# Agenda HISTORIC DISTRICT COMMISSION

Regular meeting 6:30 p.m. March 6, 2024 Board Meeting Room of Town Hall Annex, 105 E. Corbin St.

### ITEM #6. A:

### ITEM #7. A:

ROOF PLAN & MODULES

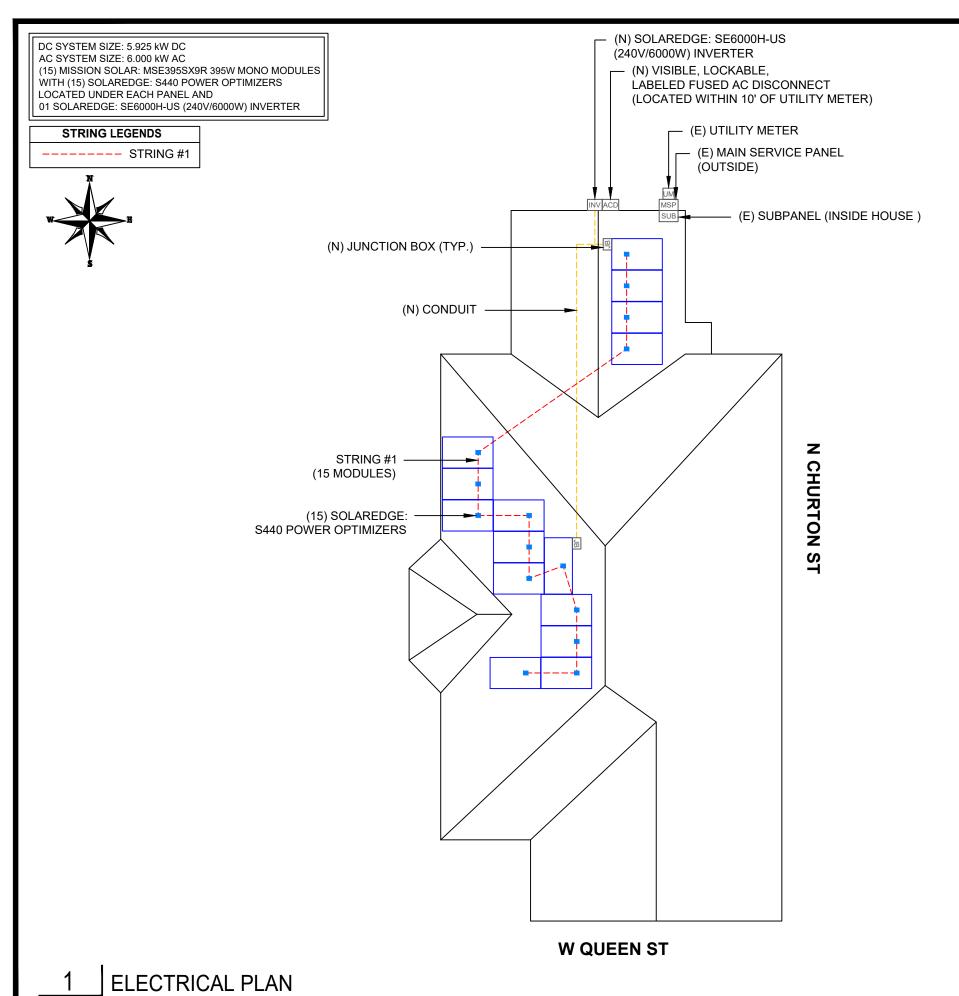
- The solar panels on the ell face Churton Street so require commission approval. The other panels do not face a street and would meet the minor works requirements. Staff recommend treating this proposal as one application, approving the panels that are not visible from Churton Street, and deliberating about the panels that face Churton Street.
- The east-facing solar panels three buildings away at 116 W. Queen Street are visible from Churton Street.

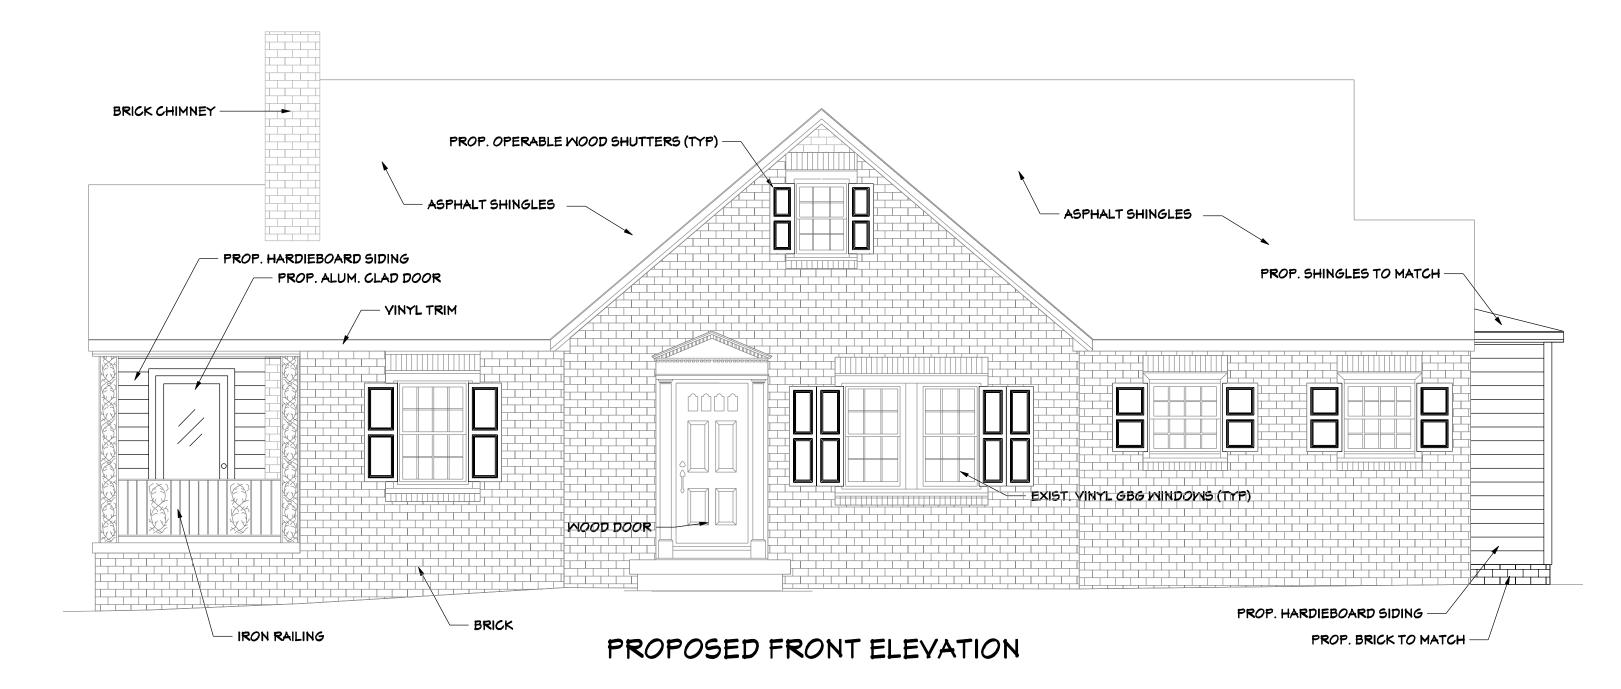
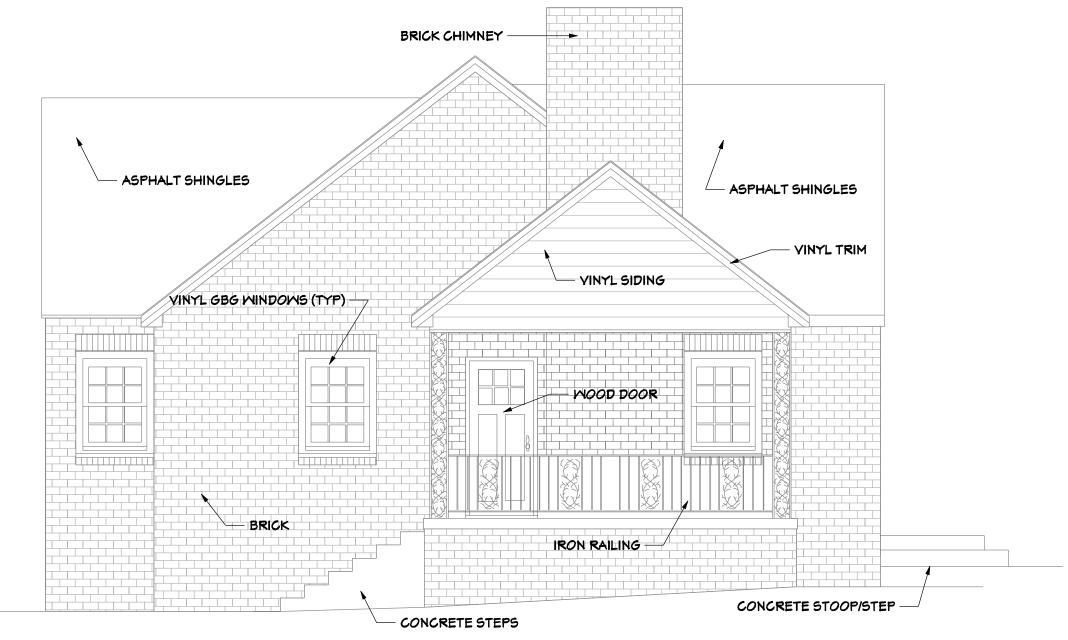
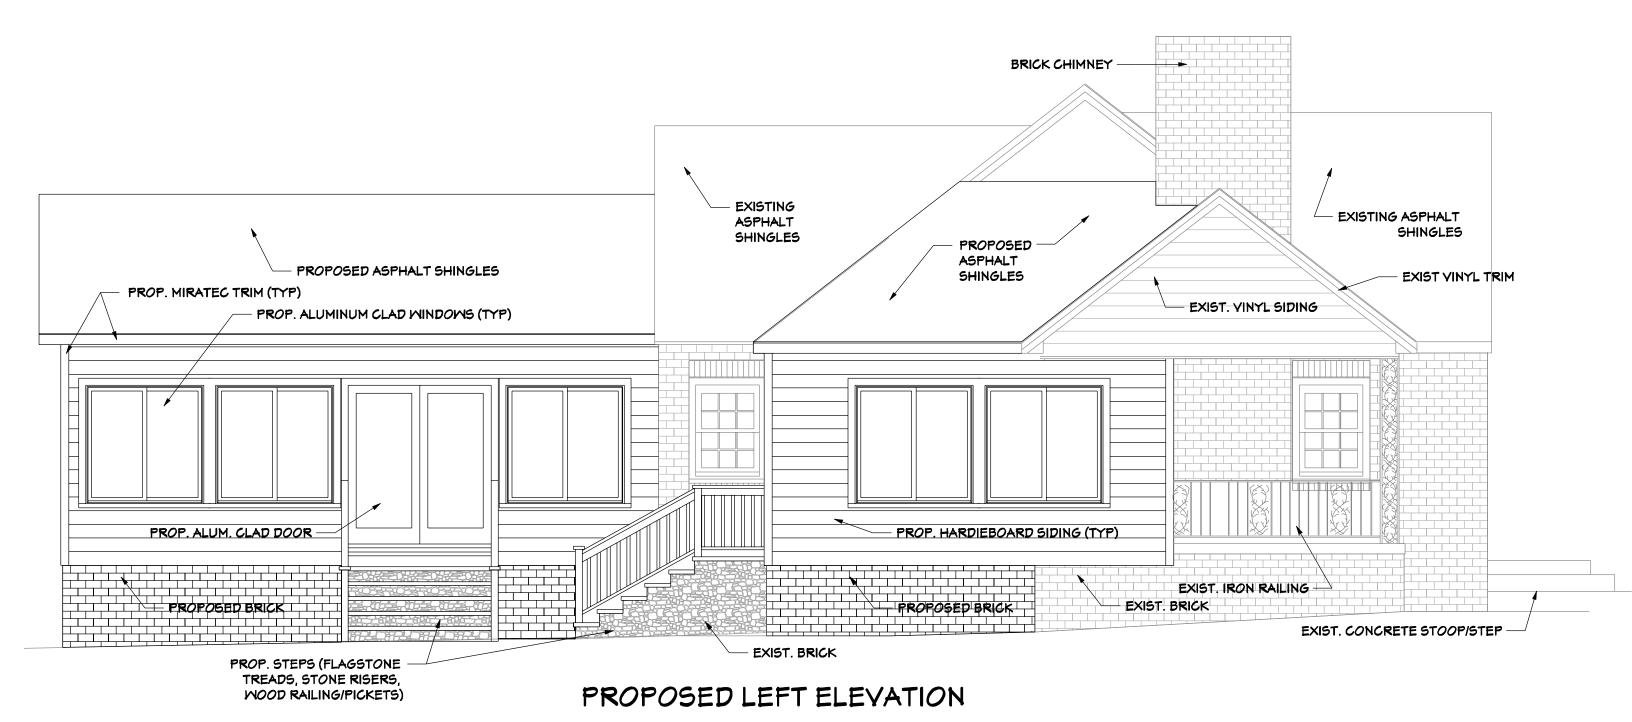
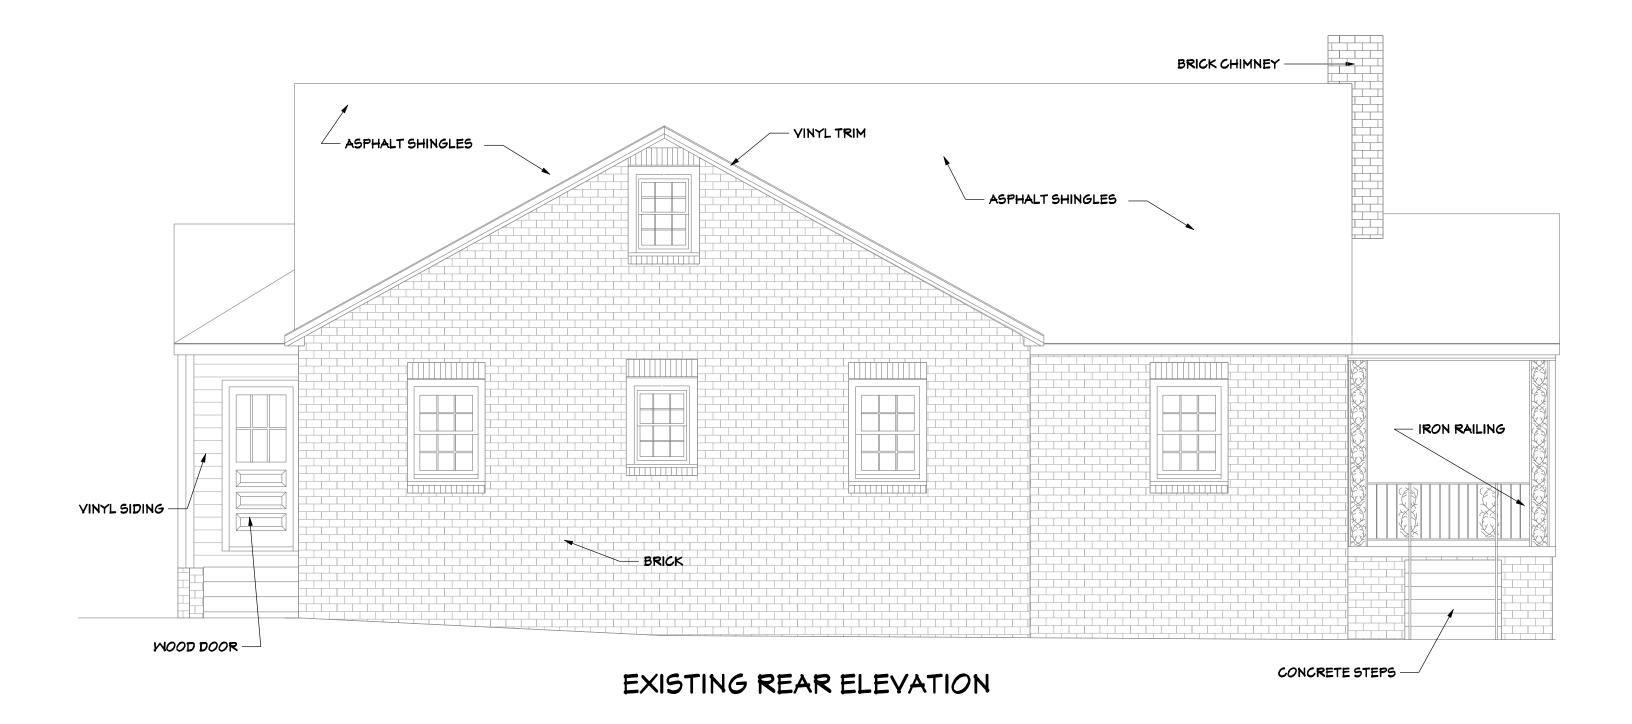
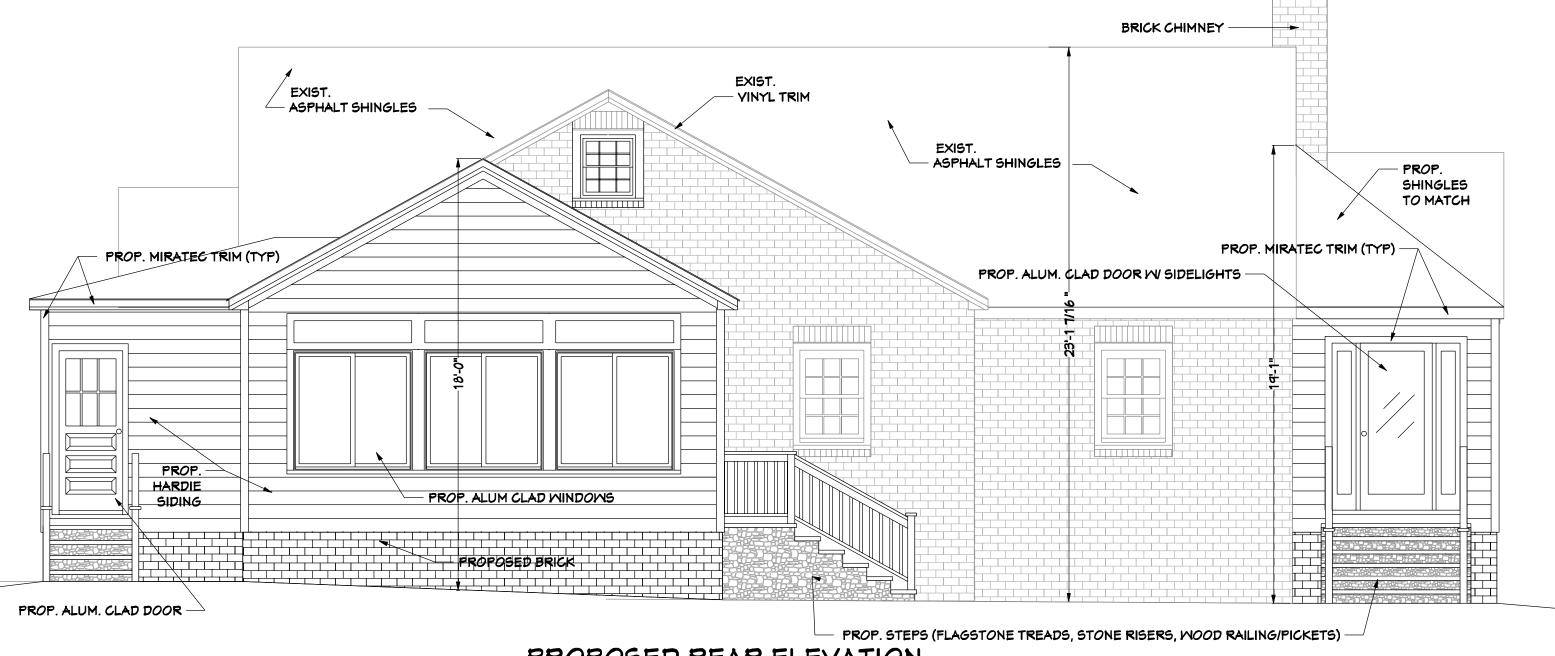
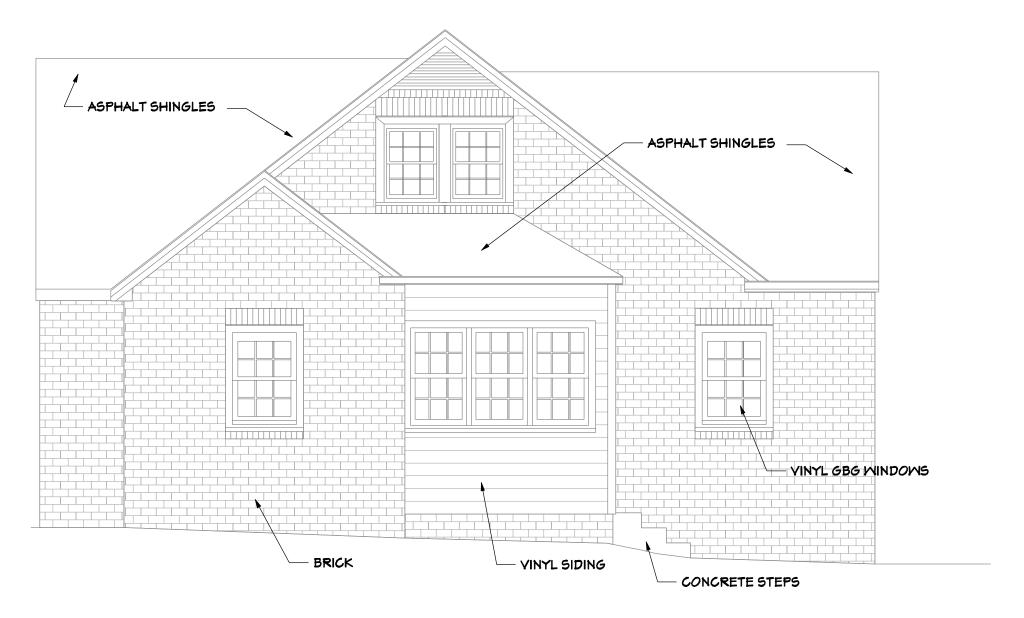
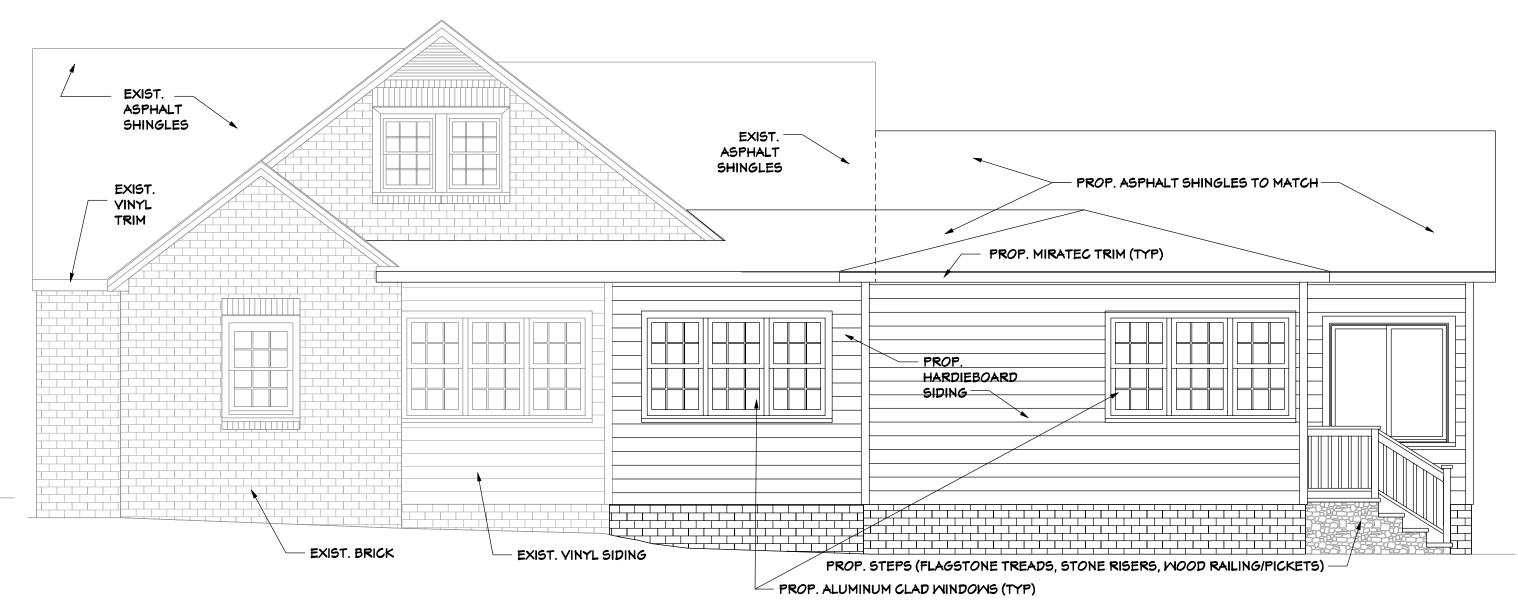
- The partially enclosed side porch and the added door to it would be visible from the street, and the relevant standards have been highlighted on the previous page.
